Bryant Planning Commission Meeting

Date: March 10, 2025 - **Time:** 6:00 PM

4. Hawkins Valley Phase 1 - Preliminary Plat

GarNat Engineering - Requesting Preliminary Plat Approval

CONTENTS:
INLET BASIN PLAN

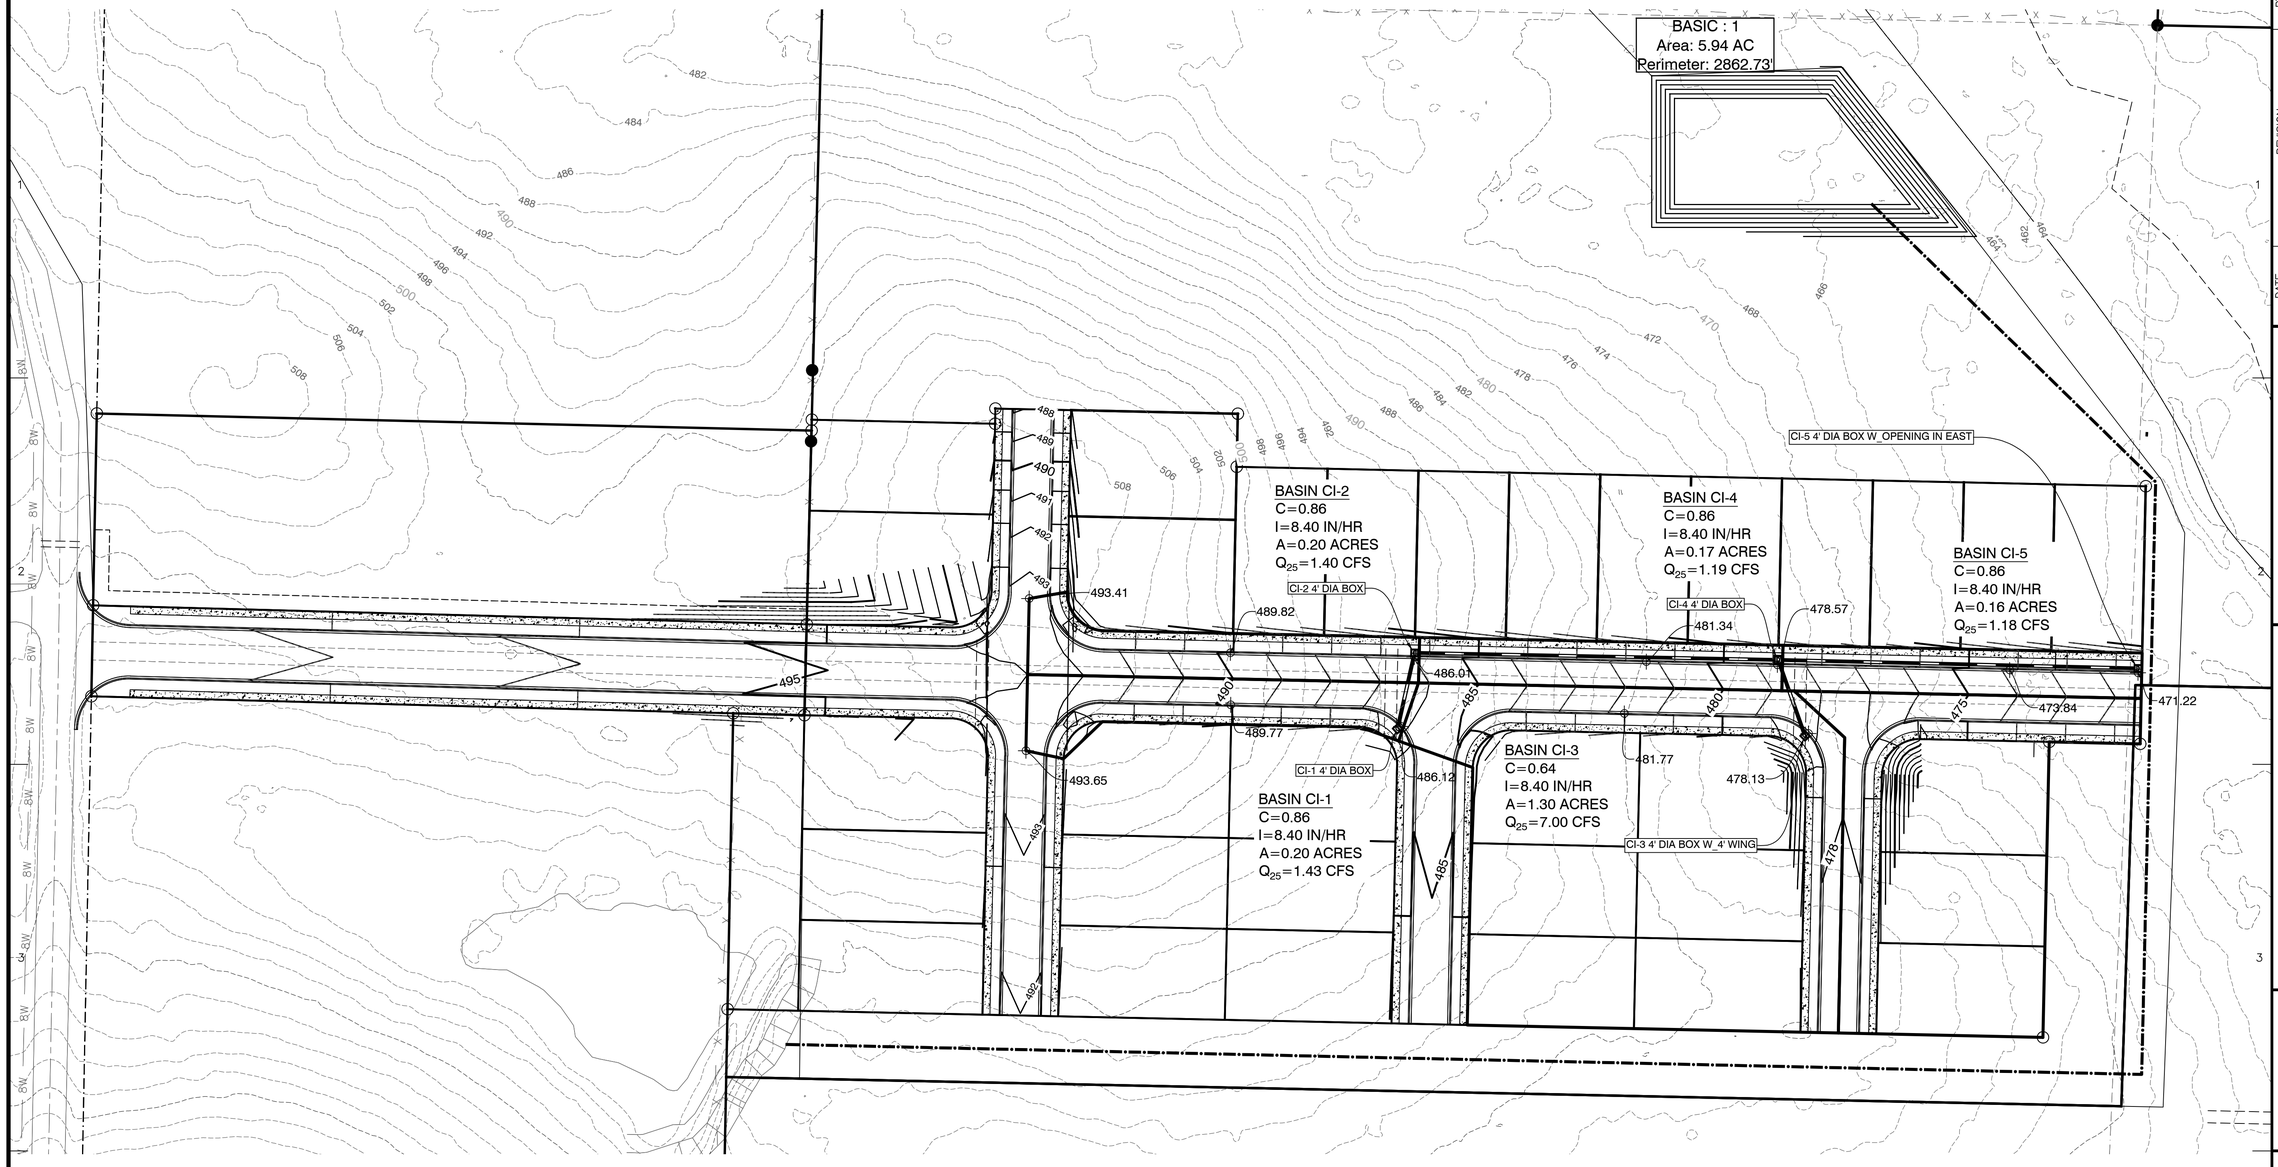
4. Pages 11 & 12 – verify drainage basins SEE BELOW***
5. Page 13 – see comments on plan sheet PIPE SLOPES, SIZES, DITCH DETAILS, AND WEIR DETAILS ADDED. SEE PAGE 26 & 27.

6. Page 21 – Show enclosed storm pipe calculations for inside proposed phase PIPE SIZE CALCULATED BASED ON INLET BASIN.
7. Page 21 – Show ditch sizing calculations based upon actual contributing basins DITCH IS SIZED PER CONTRIBUTING BASIN.

8. Page 22 – see other basins not included in the calculations.
    a. Show pond details and layout including control structure POND DETAILS AND WEIR DETAILS ADDED SEE PAGE 26 & 27.

b. Show pipe sizes, slopes etc PIPE SLOPES, SIZES ADDED. SEE PAGE 26
    c. Label ditch, show details,, slope, lengths, DITCH DETAILS, SLOPE AND LENGHT ADDED AND LABELLED. SEE PAGE 26 & 27.

*** WE AGREE WITH THE BASINS. HOWEVER, WE DIDN'T CHANGE THE BASIN TO MEET THE BRYANT DEADLINE. WE WOULD LIKE TO ADD OUR PROJECT TO THE FEBRUARY AGENDA. ALL FLOWS ARE RELEASED TO THE CREEK TO COMPLY WITH THE BRYANT DRAINAGE CODE.

CONTENTS:
STREET & DRAINAGE PLAN

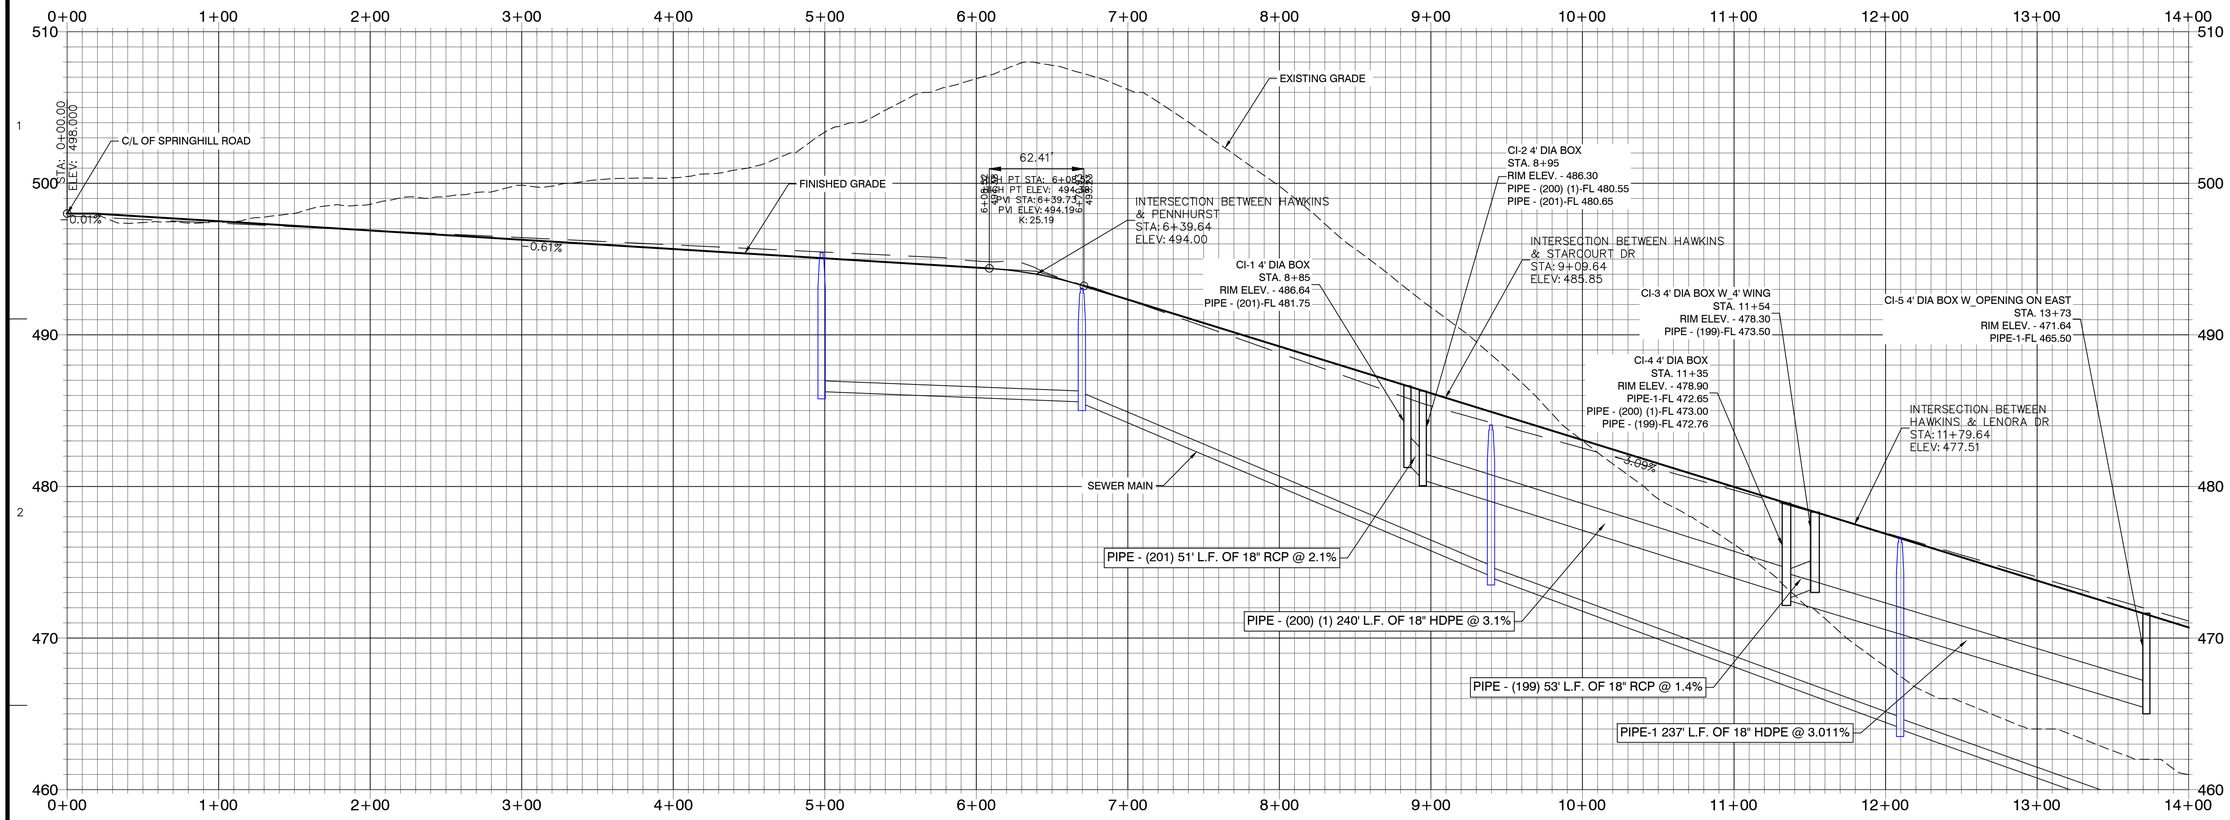
GNE response to comments drawn in red
